SERVICE BULLETIN

RDR-1700 WEATHER RADAR SYSTEM

AA-1504A Antenna Array
P/N 4001943-0404

Incorrect Decal Placement

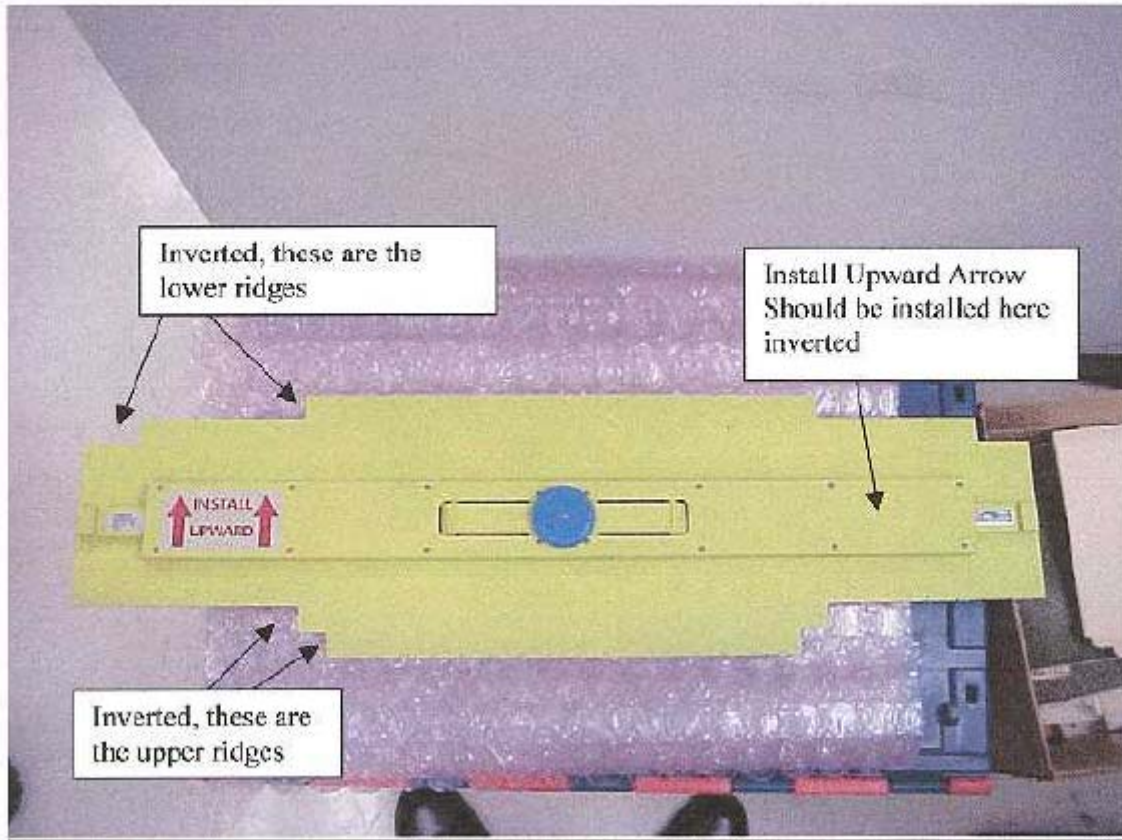
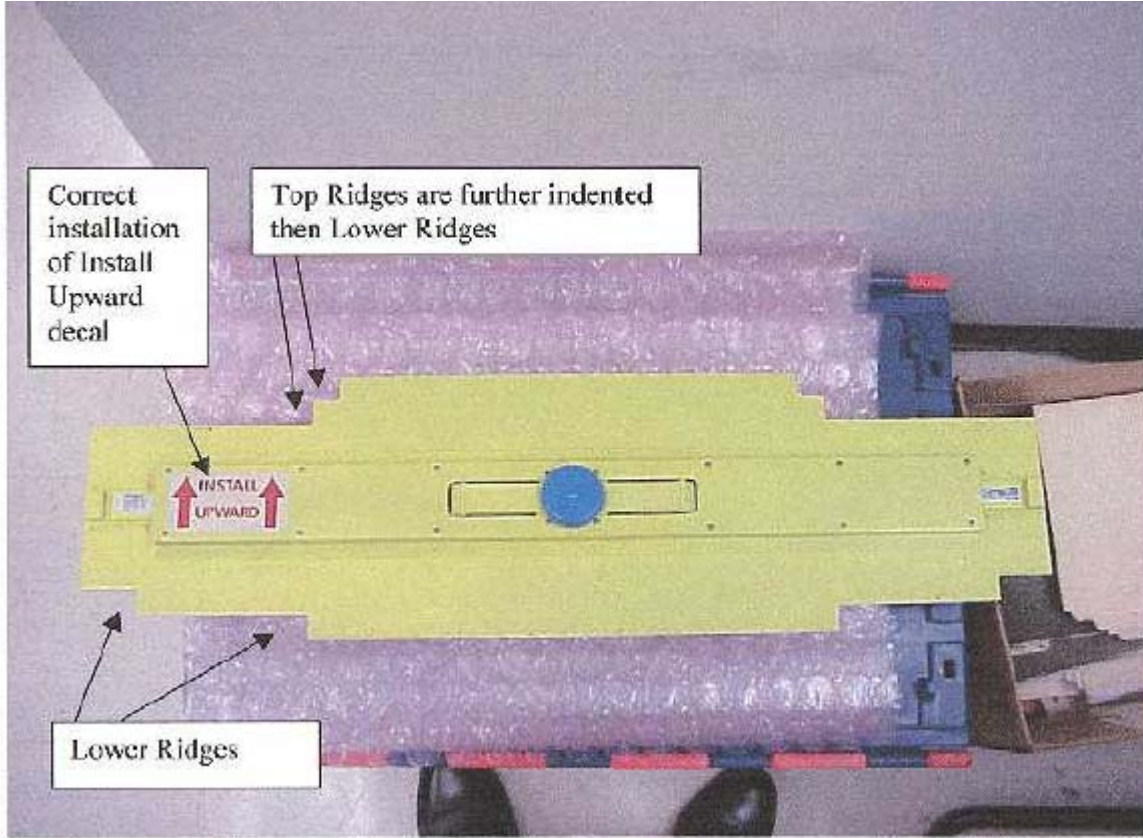
Manufacturing error resulted in improper placement of caution decal.

Units should be inspected to ascertain proper decal placement per the following illustrations. If decal was installed incorrectly, remove the decal and install a new decal in the proper orientation.

Correct Decal Placement
